**PC #15-004**

**Hillside Towing**

**Round 2 Comments- October 2, 2015**

**Re: Response to Plan Commission Round 2 Comments**  
Petitioner: Hillside Auto Body & Service, Inc.  
Property: 25 E. University Drive, Arlington Heights  
PIN No. 03-08-103-0004-0000  
File No.: P.C. 15-004

Hillside Auto Body & Service, Inc.  
Floor Plan

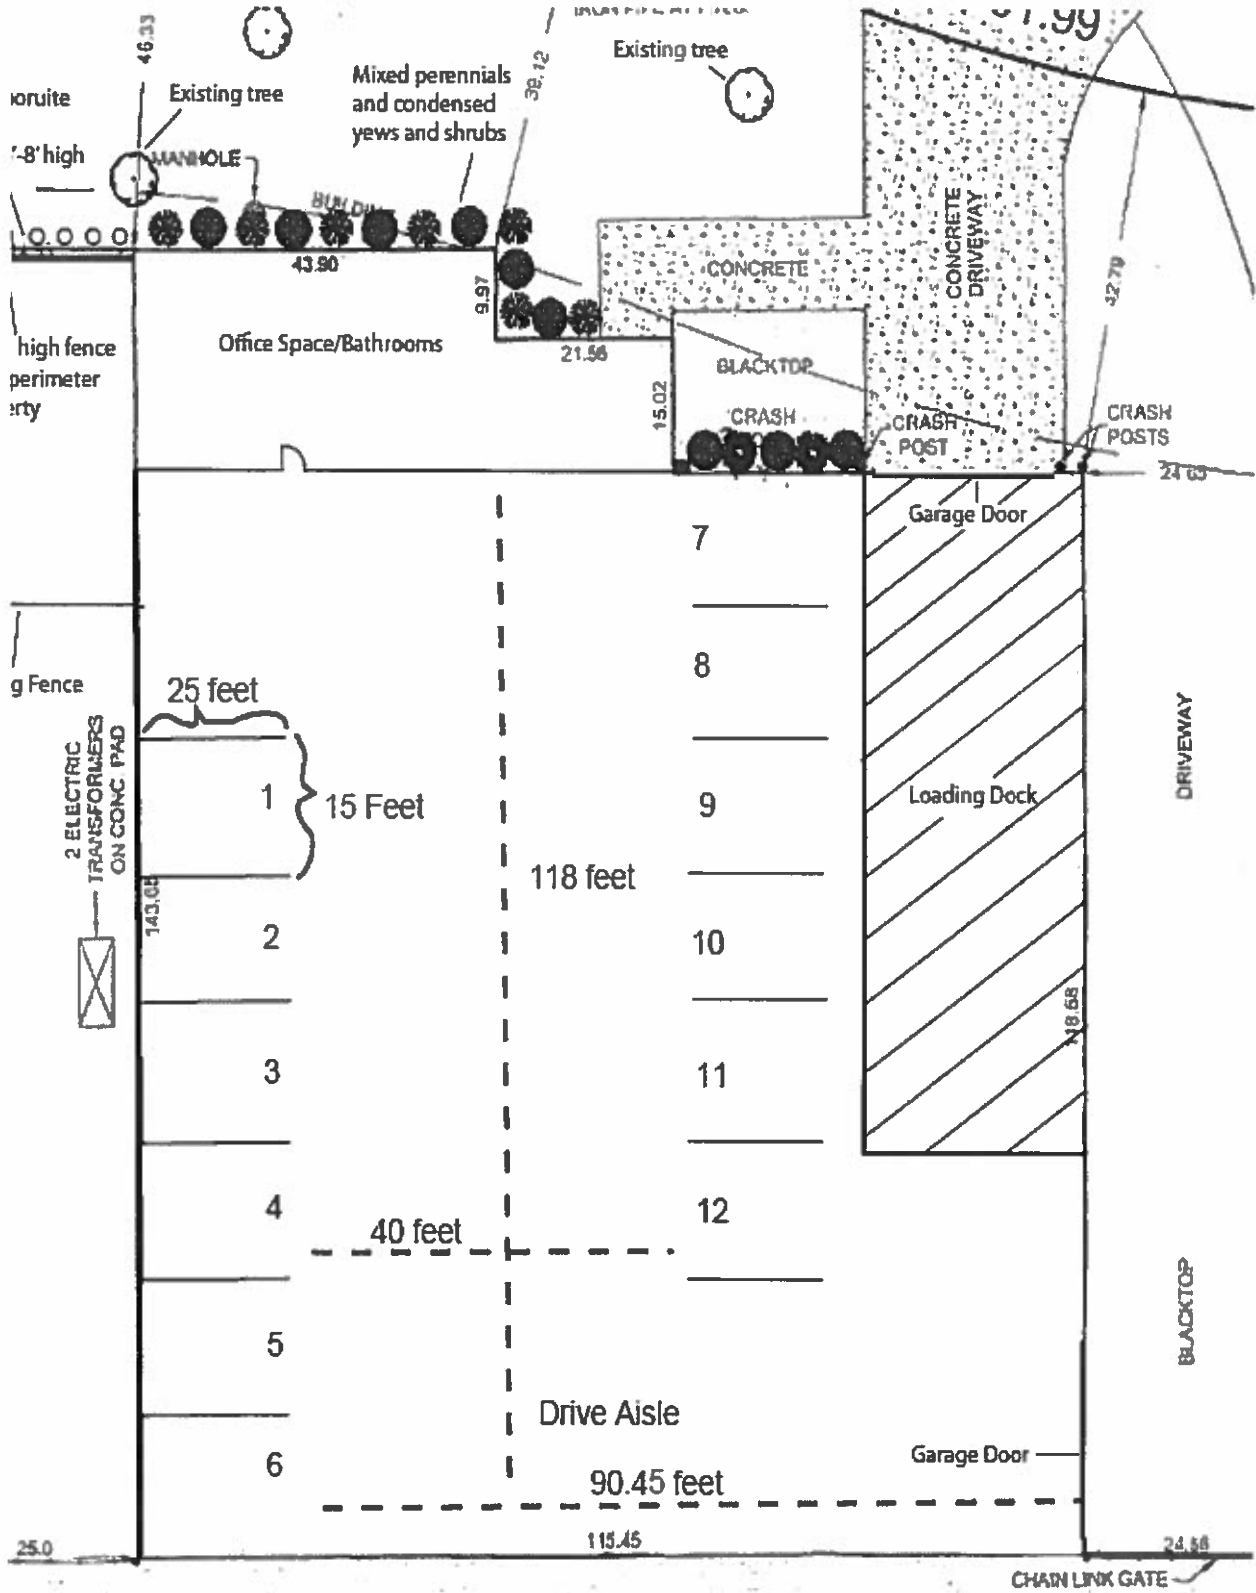
6. Please revise the floor plan and label each of the bays by number to clearly delineate the bays. Also provide dimensions on the floor plan for a typical bay and the drive aisles.

*Response:* Please see attached Revised Floor Plan. At this time, Hillside anticipates 12 bays that will be approximately 25 feet by 15 feet each, with a drive aisle from the side garage and down the center.
